ATTACHMENT A

### Beaver Valley Power Station, Unit No. 2 Proposed Technical Specification Change No. 38 REACTOR TRIP INSTRUMENTATION REVISION RTD BYPASS ELIMINATION

ATTACHMENT C

Proposed Technical Specification Change No. 38

FIGURE 5.1-1 (SH. 1 OF 2)  
 PROCESS FLOW DIAGRAM  
 REACTOR COOLANT SYSTEM  
 BEAVER VALLEY POWER STATION-UNIT 2  
 FINAL SAFETY ANALYSIS REPORT

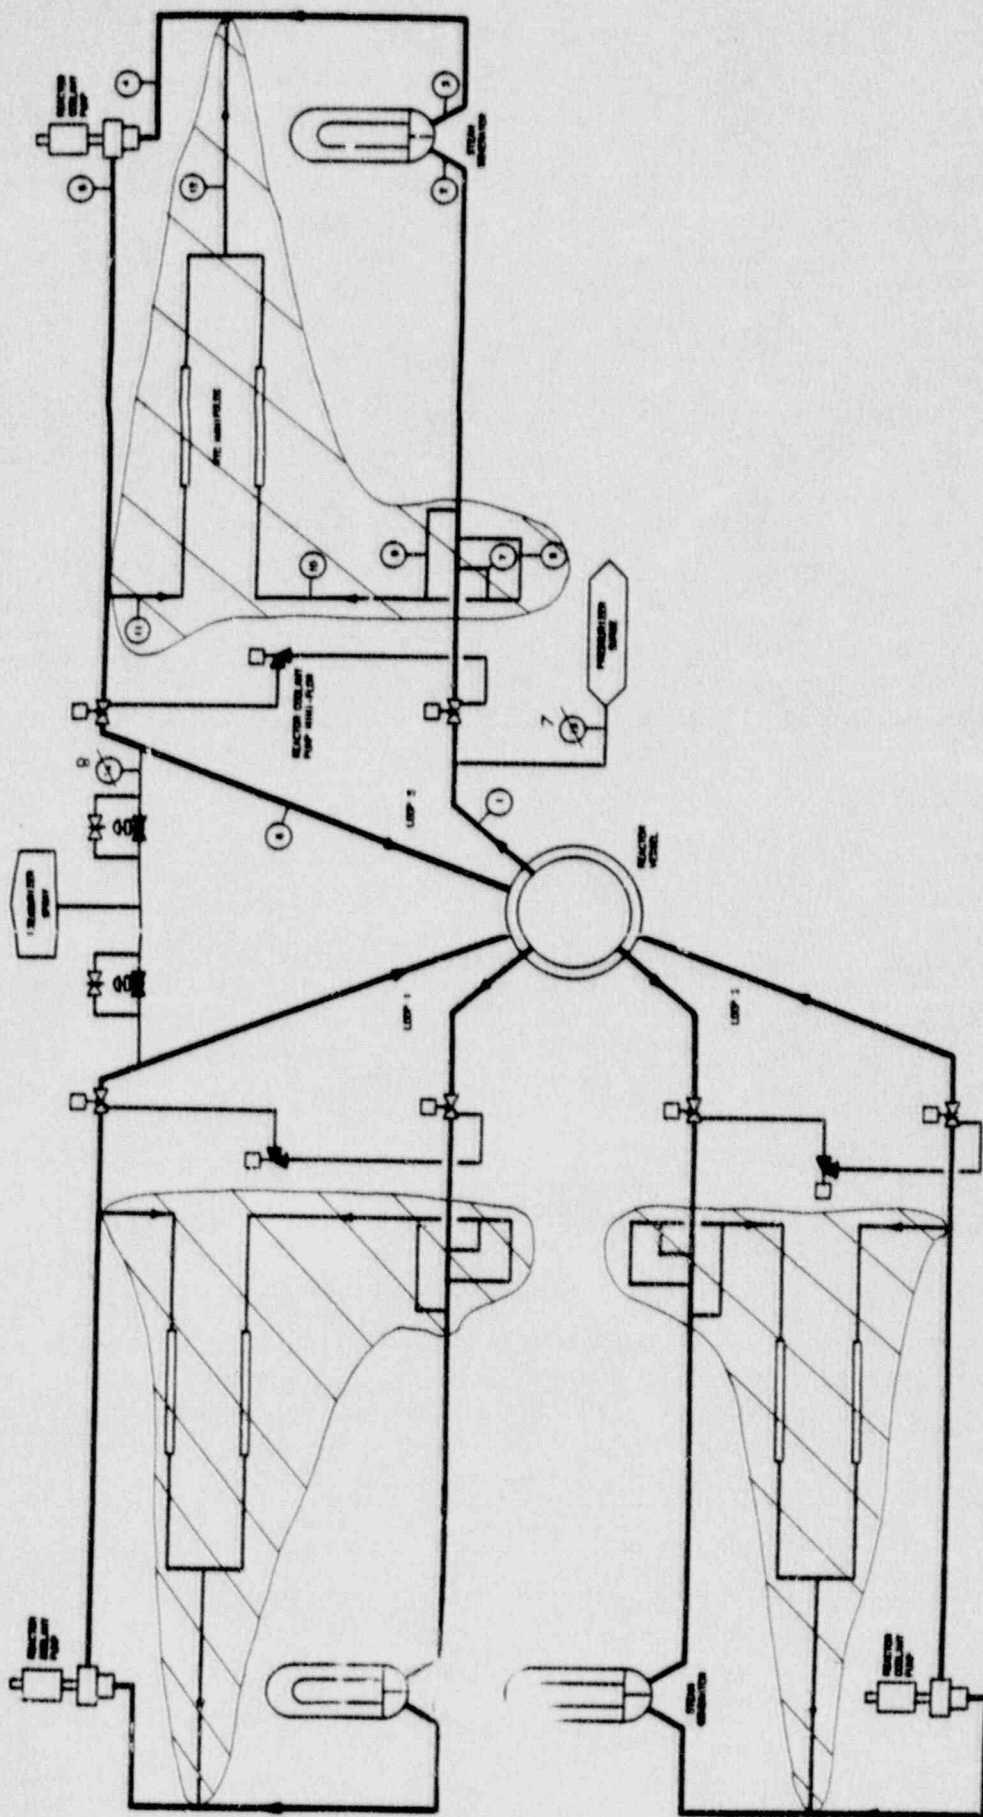
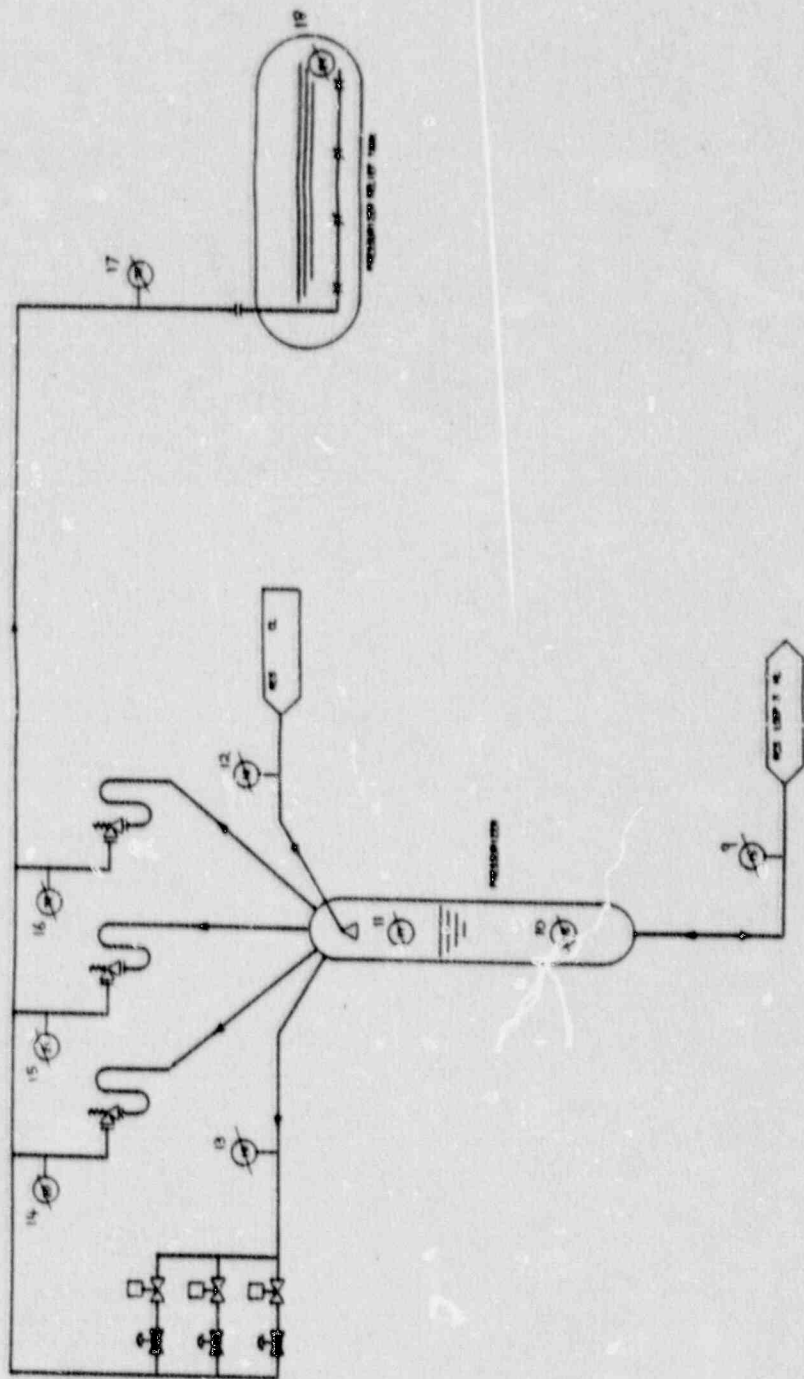
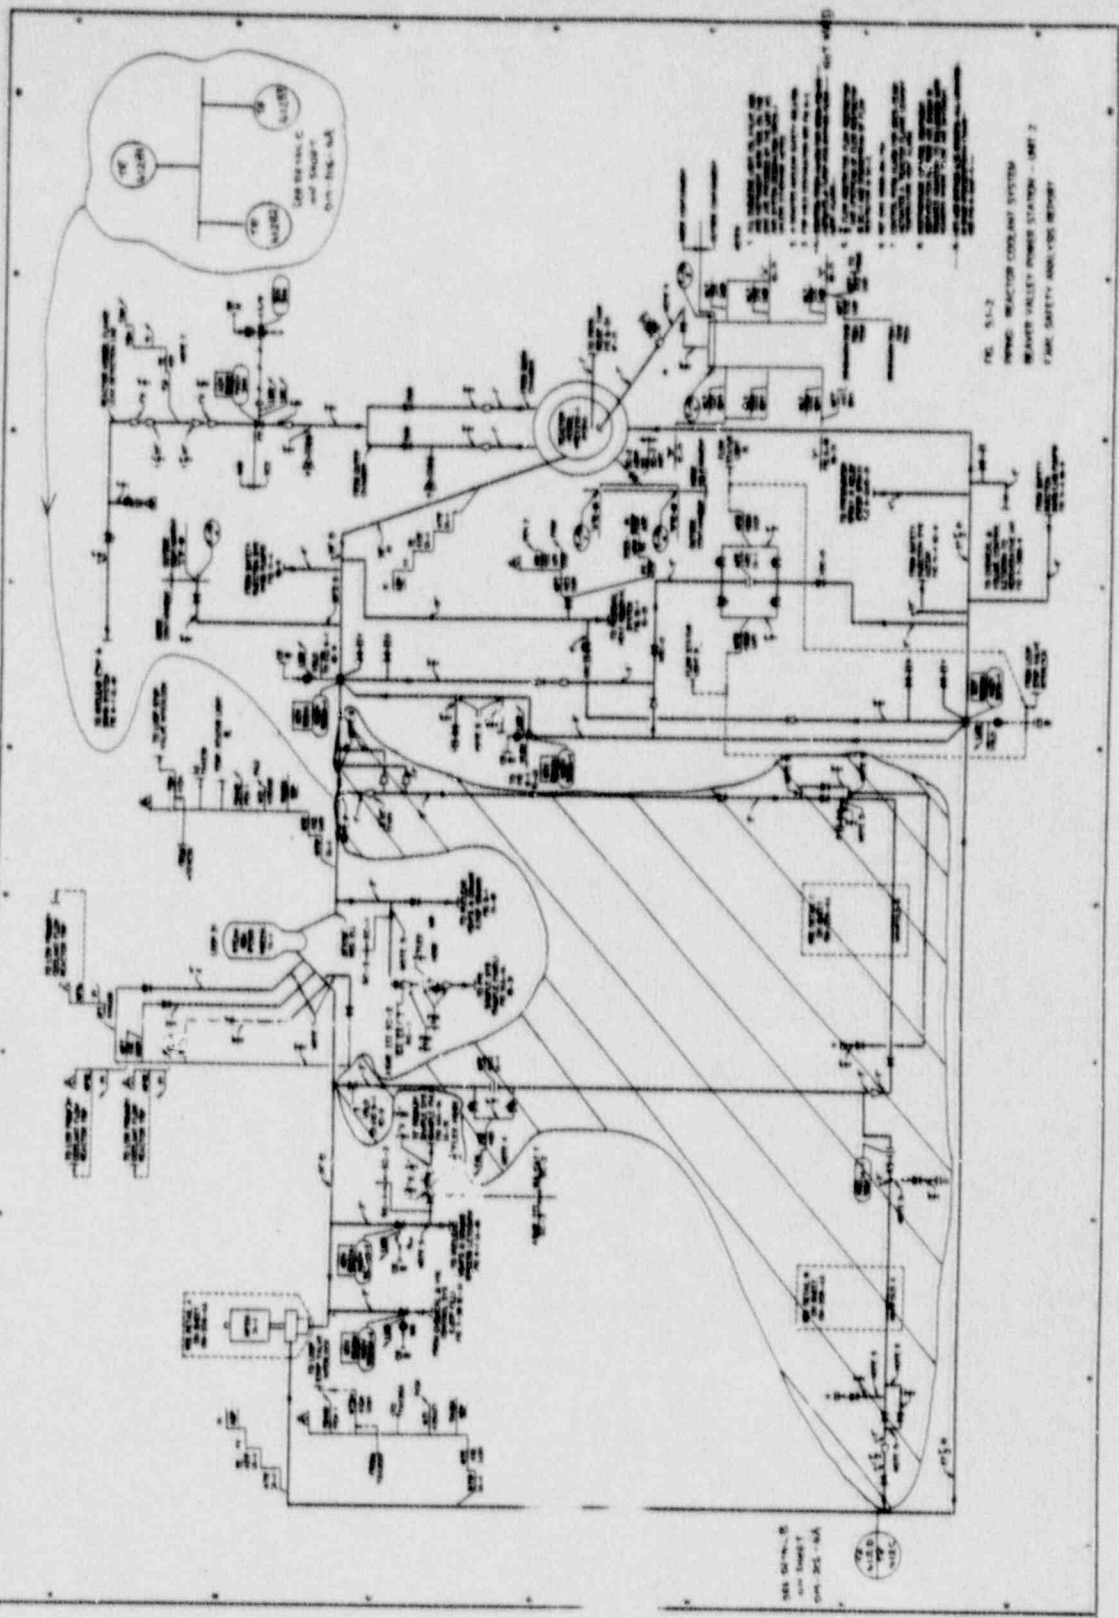
7.2.2.3.2 describes the monitoring and testing used to demonstrate the accuracy of the RTD temperature measurements. UFSAR Figures 5.1-1 through 5.1-7 illustrate the existing RTD bypass piping configuration. These and other sections of the UFSAR will be revised as shown in Attachment C to address the design modifications as well as describe how the new thermowell mounted RTDs will be used in the control and protection functions of the plant.
